## Process Change Notification

**Title: MCC Will Use Glass Passivated Chip For UF4001~UF4007 Rectifiers**

**PCN#: 032818-1**

**Changed Part Identification Example:**

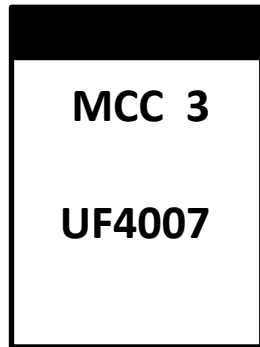
To be more environment friendly and provide more robust parts to our customers, MCC will use glass passivated chip (GPP) to replace OJ chip (Open Junction) for UF4001~UF4007 series rectifiers. GPP structure is more reliable and has better performances than OJ structure, internal qualification process had been finished and the report is available by individual request. To identify the parts with GPP chip inside, MCC will assign new line code on body (see next page for details).
